SUTHERLAND SHIRE COUNCIL ASSESSMENT REPORT

Panel Reference	PPSSSH-85
DA Number	DA21/0610
LGA	Sutherland Shire Council
Proposed Development	Demolition of existing structures and construction of a mixed-use development comprising ground level commercial tenancies, 48 residential apartments above and strata subdivision
Street Address	344-346 and 348R Kingsway, Caringbah
Applicant/Owner	344-346 Kingsway Pty Limited
Date of DA lodgement	30 June 2021
Number of Submissions	7 (two from one submitter)
Recommendation	Refusal
Regional Development Criteria (Schedule 7 of the SEPP (State and Regional Development) 2011)	The proposed development has a capital investment value of more than \$30 million, estimated at (\$45,126,950.00).
List of all relevant s4.15(1)(a) matters	<ul style="list-style-type: none"> State Environmental Planning Policy (Building Sustainability Index: BASIX) 2004. State Environmental Planning Policy No. 55 – Remediation of Land (SEPP 55). State Environmental Planning Policy No. 65 – Design Quality of Residential Flat Development (SEPP 65). Apartment Design guide (ADG) State Environmental Planning Policy (State and Regional Development) 2011. State Environmental Planning P

Figure 5: Height Plane diagram

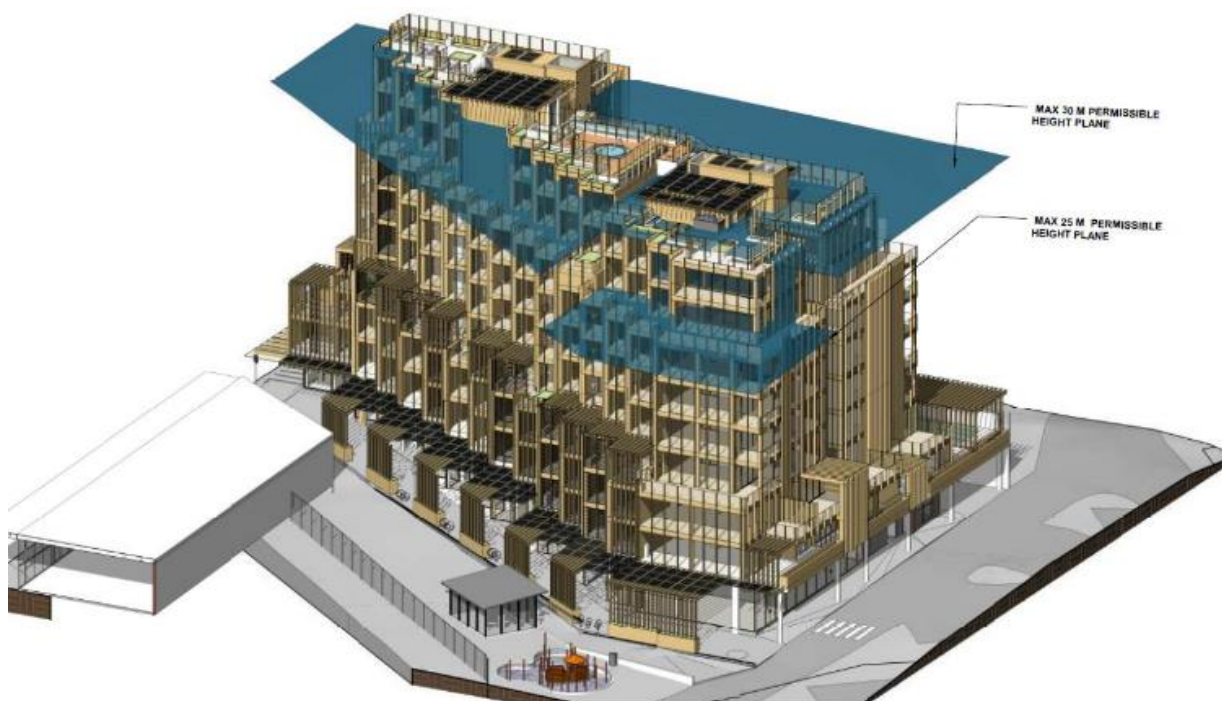
25m max (344 – 346 Kingsway) – 32.2m (to the roof top open space and building - core T2) (28% variation)
- 33.4m (to the lift over run - core T2) (33.6% variation)
20m max (348R Kingsway) - 34.25m (core T1) which falls within the 30m height of building area. (14% variation)

The varied building height of the development is demonstrated in the height plane diagram provided by the applicant in their Clause 4.6 exception, an excerpt of which is included (see below).

The applicant’s written submission fails to demonstrate that compliance with the height development standard is unreasonable or unnecessary in the circumstances of the case. It also fails to demonstrate sufficient environmental planning grounds to justify varying this development standard.

The proposed development does not satisfy sub-clause 2E, as the proposed development does not include all lots within ‘Area 1’ or provide a pedestrian plaza and vehicular access to 340 Kingsway, Caringbah. The proposed development should be amended to comply with the maximum building heights permitted by clause 4.4(2).

Figure 7: Extract of amalgamation plan from SSDCP 2015

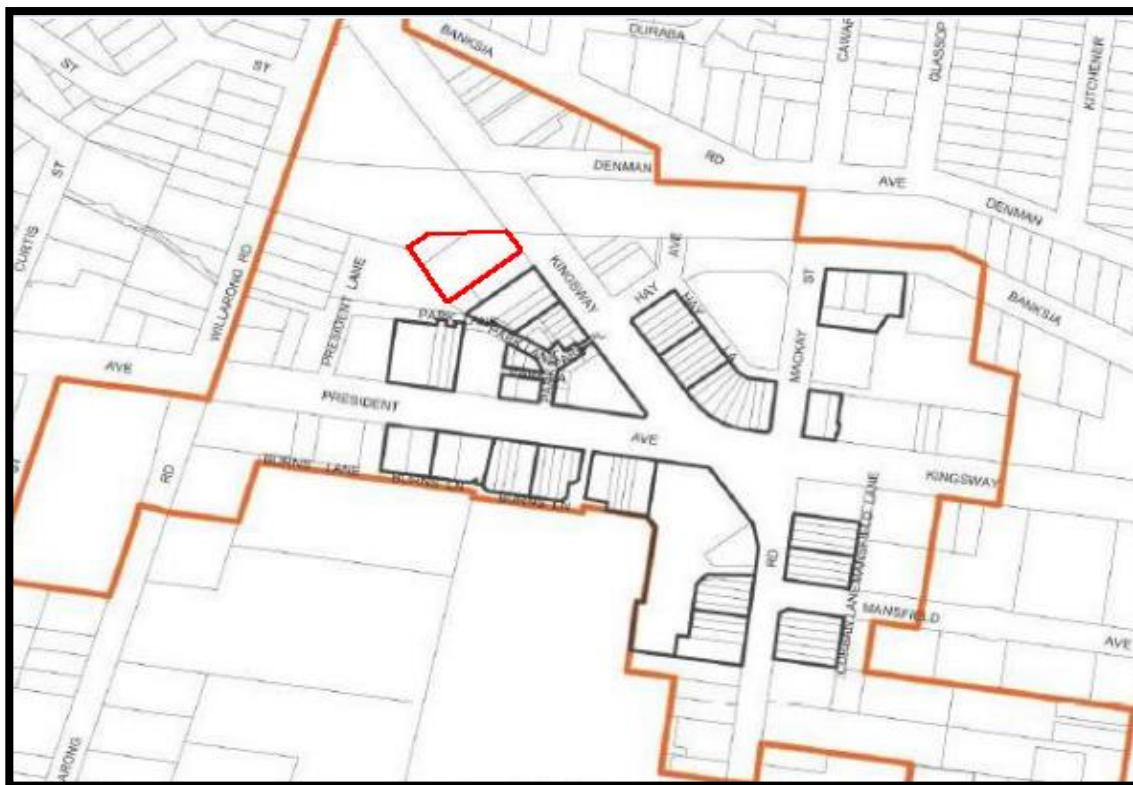
Concern is raised with respect to the subject proposal in the event that the lots to the south east (304 to 336 Kingsway) are developed as per the amalgamation plan within SSDCP 2015. This would isolate 340 Kingsway. The applicant was requested to provide additional information demonstrating that 340 Kingsway
